STATE BUILDING CODE TECHNICAL REVIEW BOARD

Friday, May 21, 2021 - 10:00am (Virtual Meeting)

49
50 Appeal of Monica and Michael Davis; Appeal No. 20-03:
51
52 After review and consideration of the final order presented in the
53 Review Board members' agenda package, Mr. Payne moved to approve
54 the final order with the suggested editorial change to delete "d" for the
55 word "required", creating the word "require", in line 100 on page 37
56 and remove the word "do" and replace it with the word "may" in line
57 157 of page 43 of the agenda package. The motion was seconded by
58 Ms. Jackson and passed with Messrs. Pharr, Givens, Hutchins, and
59 Mays abstaining.

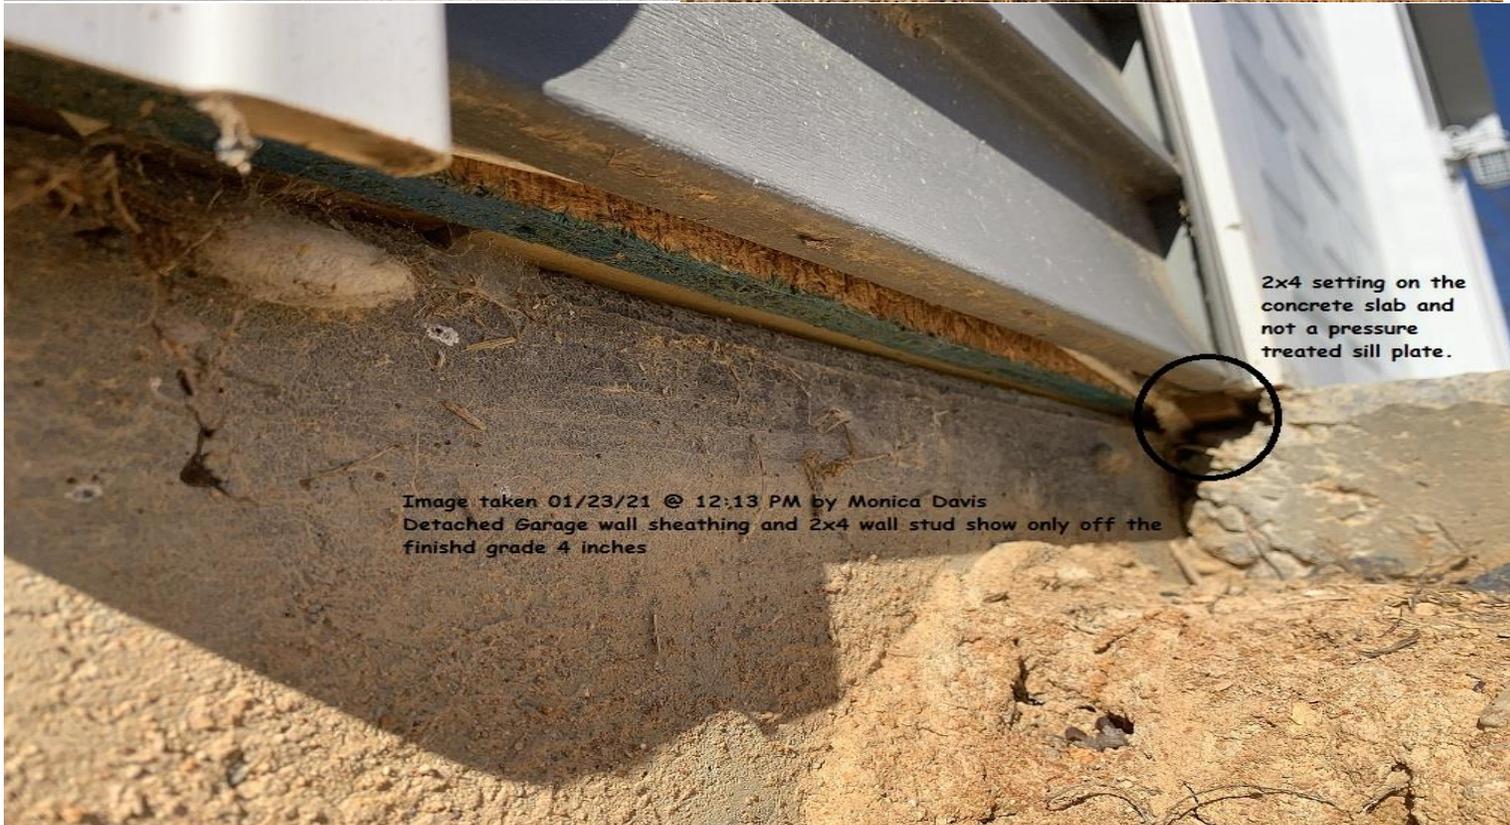
Image taken 1/12/21 @ 3 PM by
Monica Davis image shows close up
of front left corner no footing

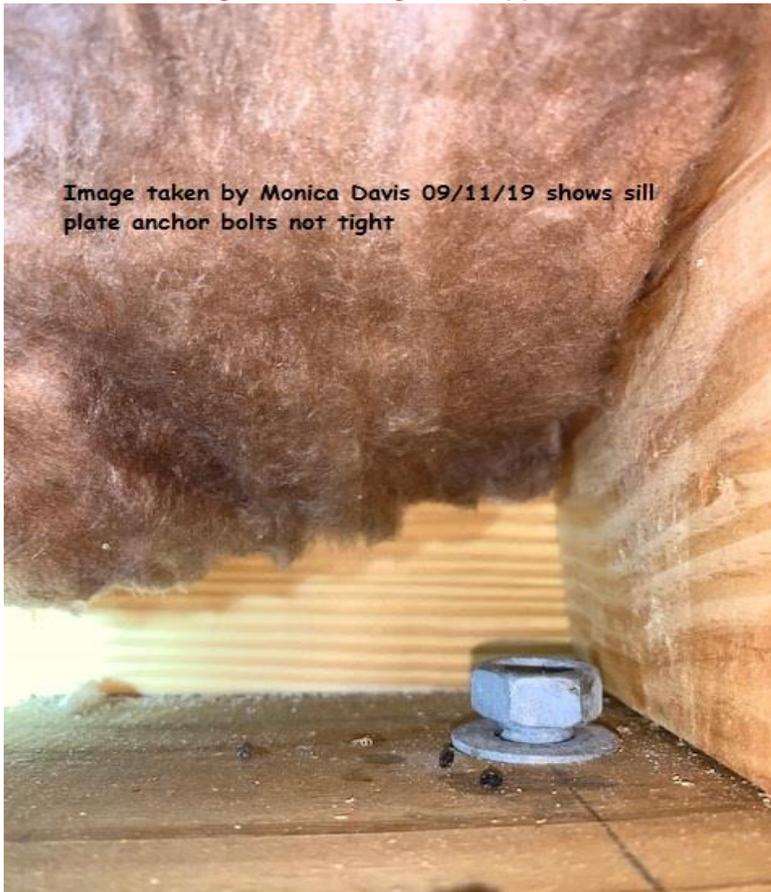
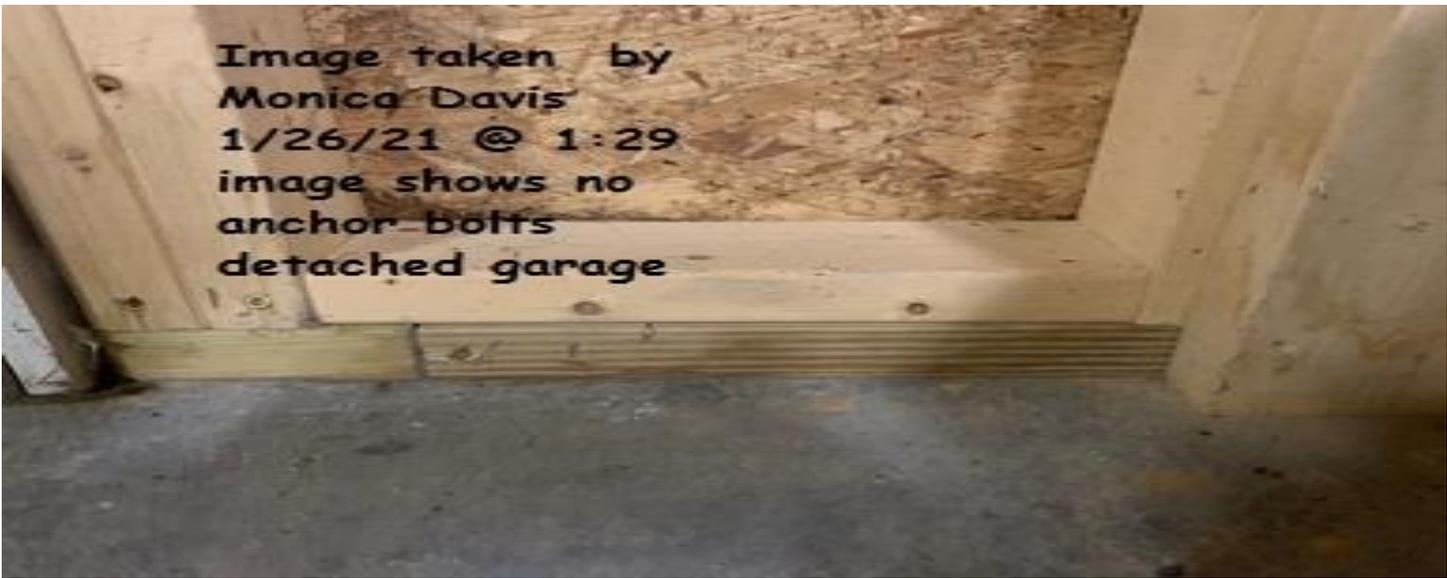
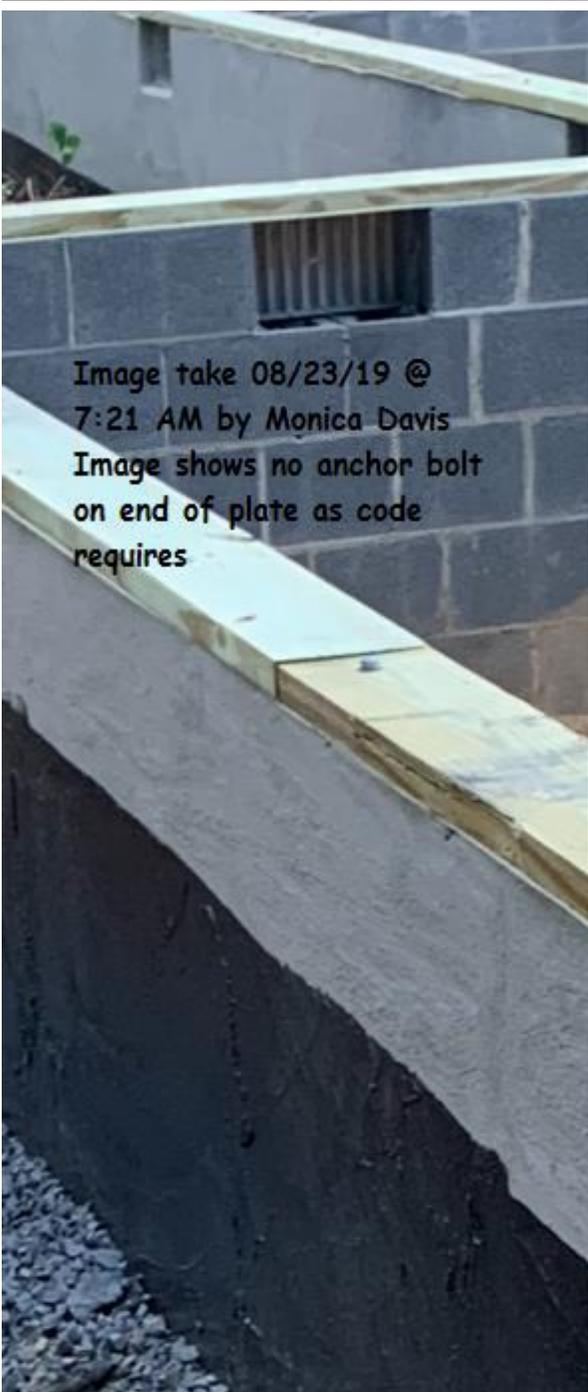
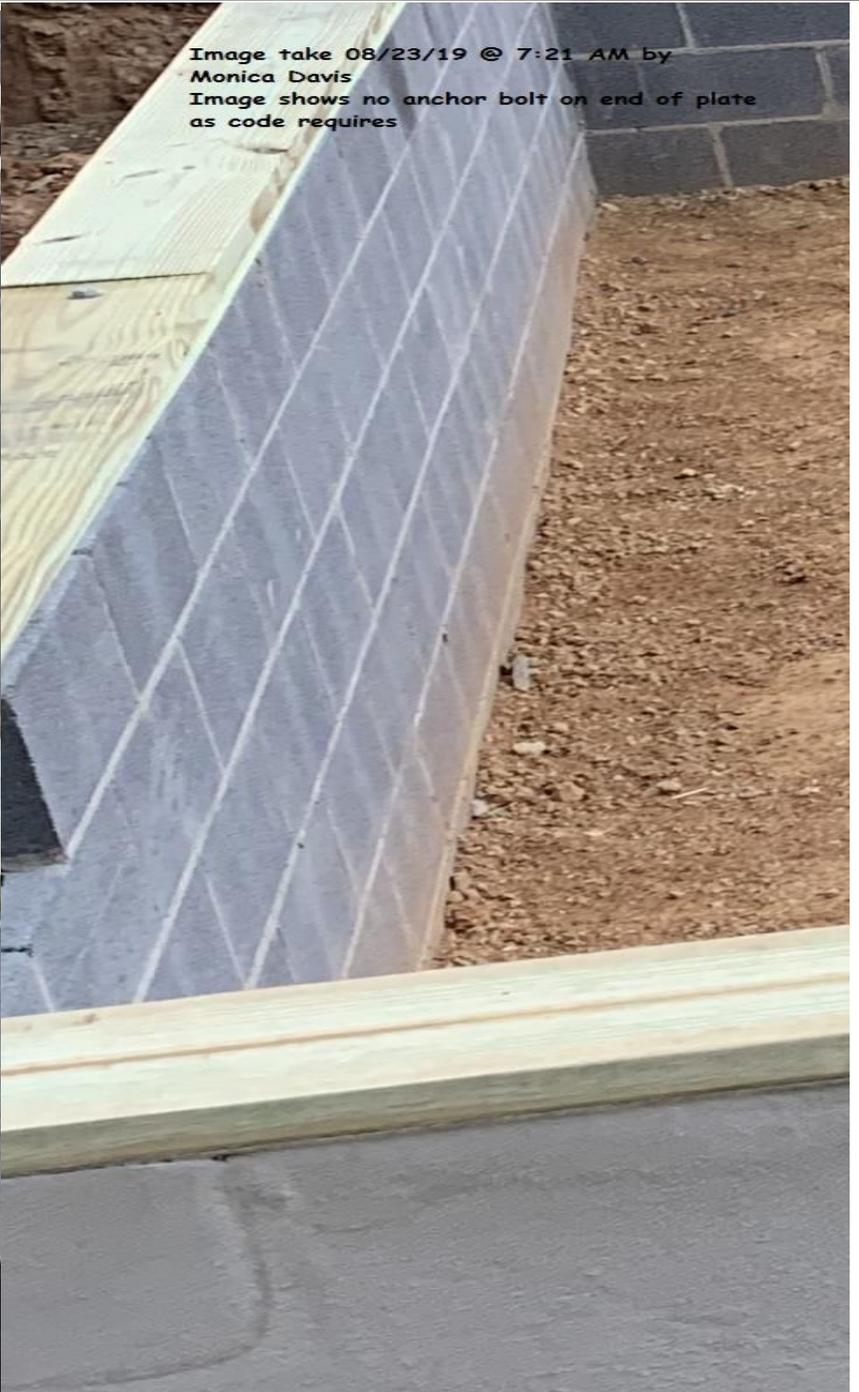
The provided images will show we do not have the minimum of one anchor within 12 inches on the end of each plate as well as we have some locations with no anchors. Below you will find several images that show we have sill plates that have NO anchor bolts at all as well as plate sections that only have ONE anchor per sill plate, and locations that do not have the required anchor within 12 inches of the end of the plate and 90% of the nuts and washer do not comply because they are not tight. You can actually take them off with your hand and no needed tools. The nuts and washers are not even snug some nuts are just screwed down one or two threads making no contact at all with the washer or sill plate. The NOV for number 3 states "Need to CORRECT to section R403.1.6 OR PROVIDE an engineered design and approval in accordance with R301.3". Number 11 in the engineer reports states they will prepare a quote for retro-fit anchor installation specifications. The verbiage clearly indicates that they have in no way, shape or form instructed the builder how to correct or provided an engineer design and approval. **So we request the board require to inforce the verbiage in the NOV and require it to be CORRECT to section R403.1.6 OR PROVIDE an engineered design and approval in accordance with R301.3.**

Image taken by
Monica Davis
1/26/21 @ 1:29
image shows no
anchor bolts
detached garage

Image take 08/23/19 @
7:21 AM by Monica Davis
Image shows no anchor bolt
on end of plate as code
requires

Image take 08/23/19 @ 7:21 AM by
Monica Davis
Image shows no anchor bolt on end of plate
as code requires

3. Sill plates in detached garage and house need anchor bolts within 12 inches of each sill plate splice in accordance with section R403.1.6. Need to correct to section R403.1.6 or provide an engineered design and approval in accordance with section R301.3.

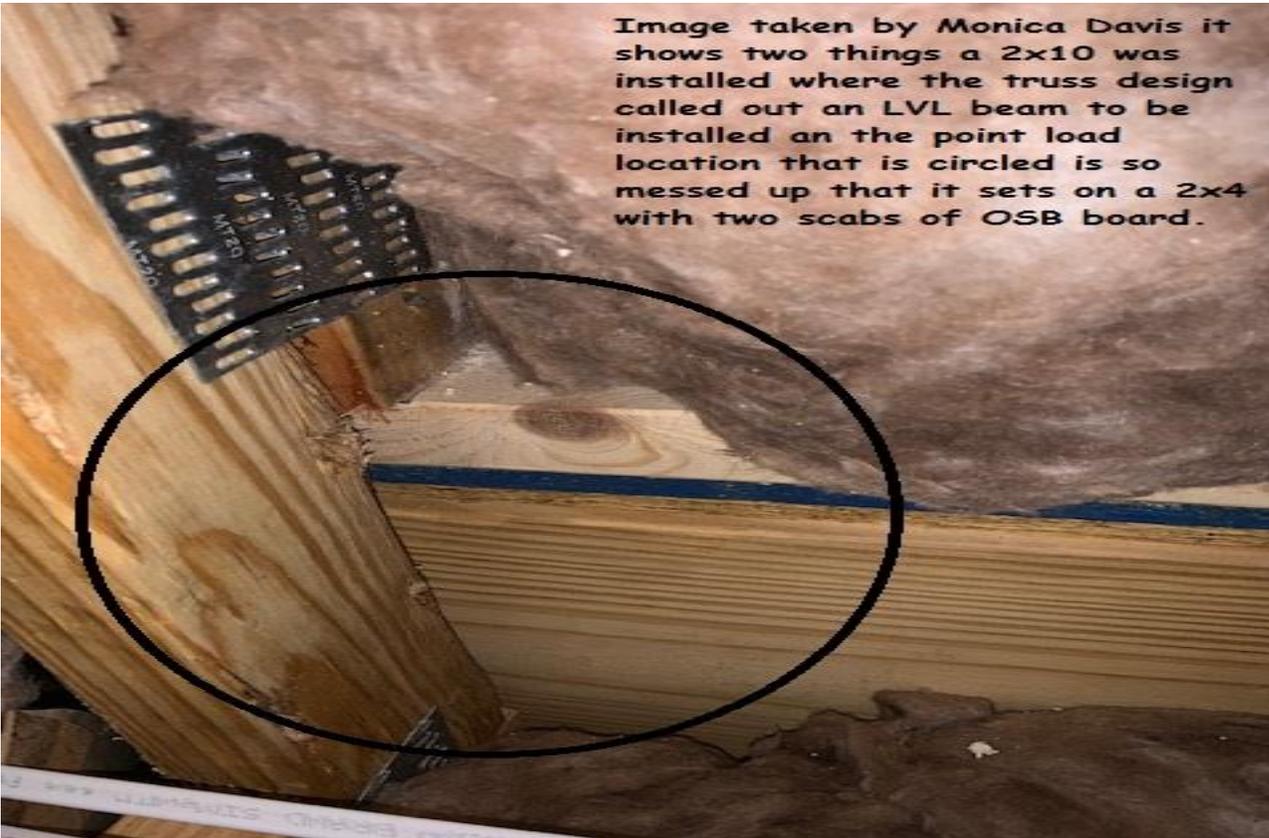
Image taken 09/11/20 by monica davis shows no hardware nails in the hanger

Image taken
09/11/19 by
monica davis shows
truss setting on
interior wall. Floor
plan design clearly
states "no interior
roof bearing has
been taken into
account for the
floor system"

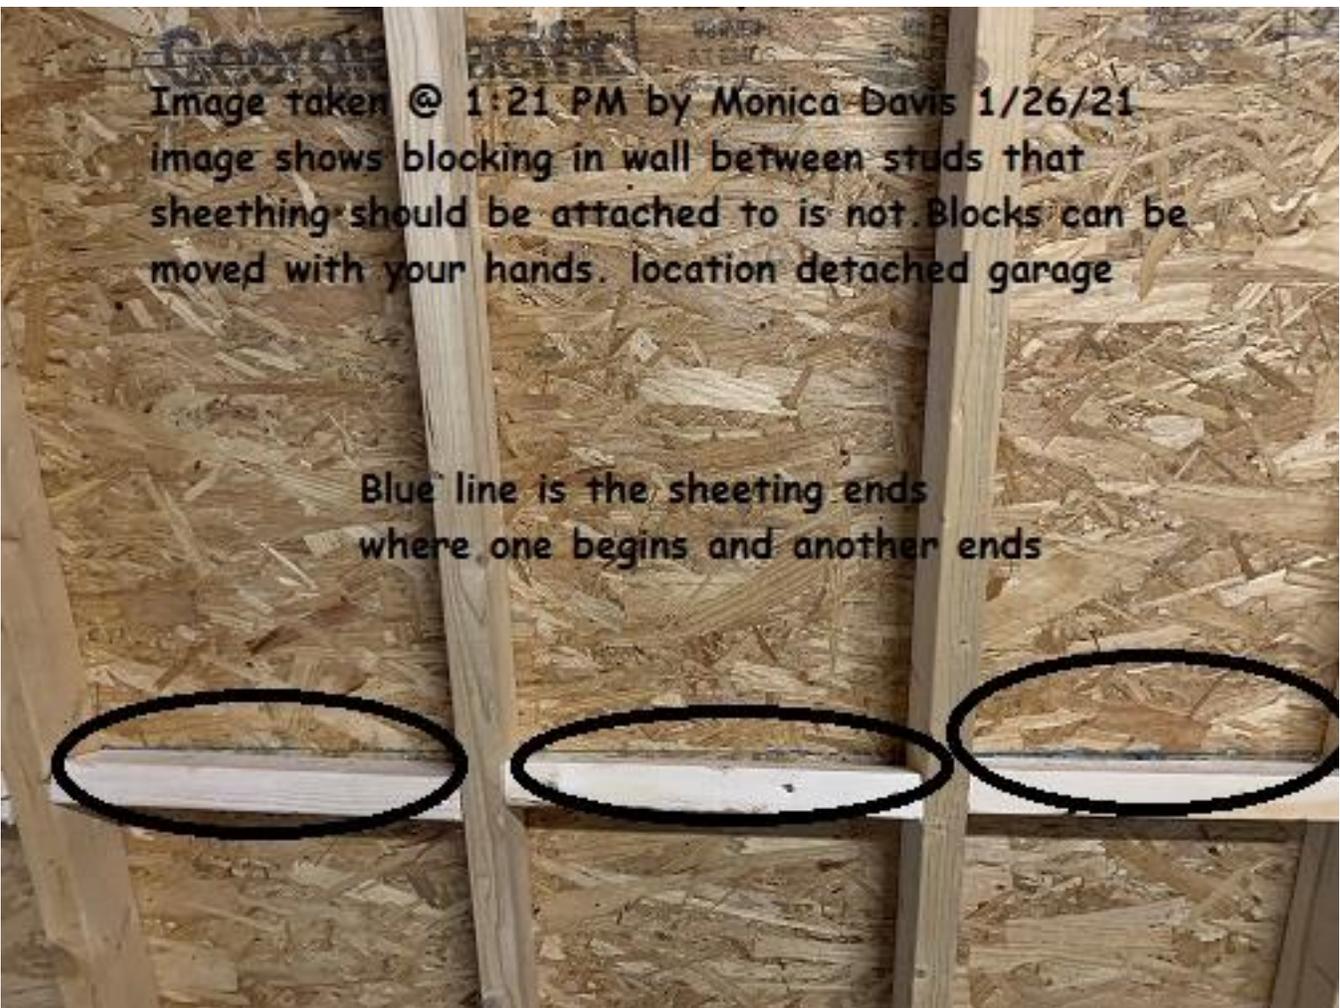
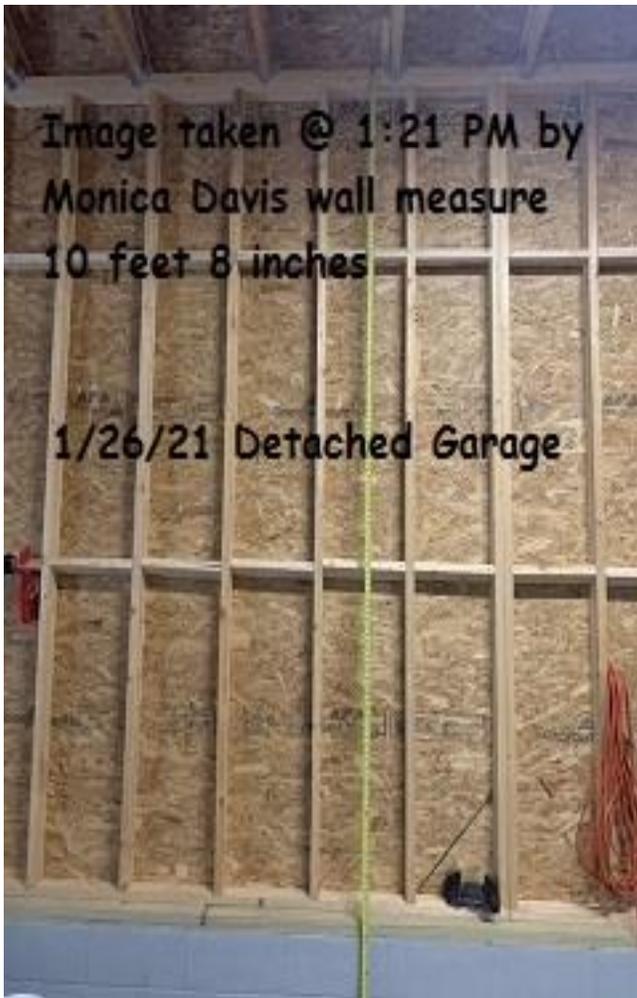
Blue line is the sheathing ends
where one begins and another ends

Image taken @ 1:21 PM by Monica Davis
1/26/21 image shows blocking in wall between
studs that sheathing should be attached to is
not. Blocks can be moved with your hands.
location detached garage

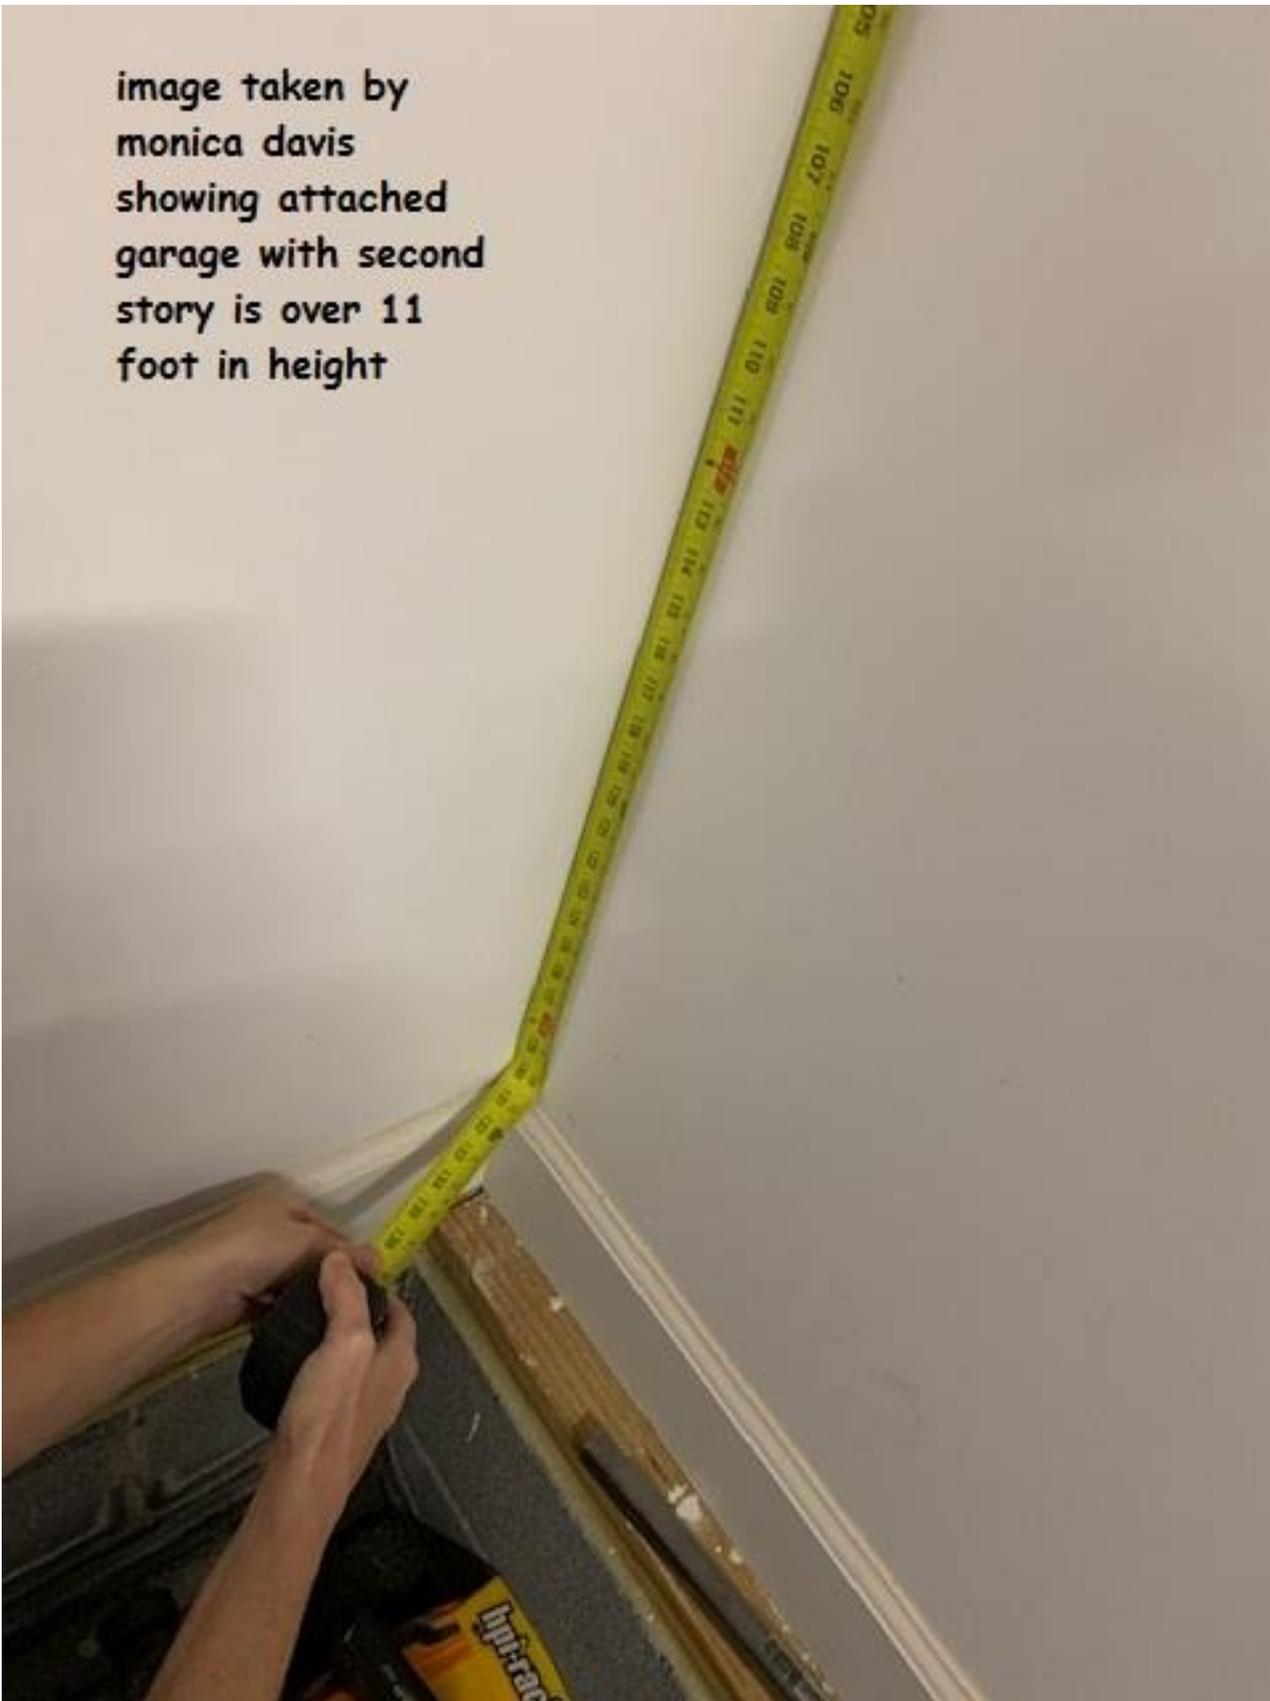
image taken by
monica davis
showing attached
garage with second
story is over 11
foot in height

image taken by
monica davis
showing attached
garage with second
story is over 11
foot in height

We request the board review the wind requirements for the exterior sheathing on both the attached and detached garage because neither structure have additional blocking. As well as address the 12 and 11 foot walls in both structures. The ridicules suggestion the engineer suggest of removing the man door (how are you to get into the structure) downsizing the door (how are we to store our vehicle in it). Again it states we the owners should contact for a design clearly calling out no analysis was taken into consideration when suggestion this silly approach.
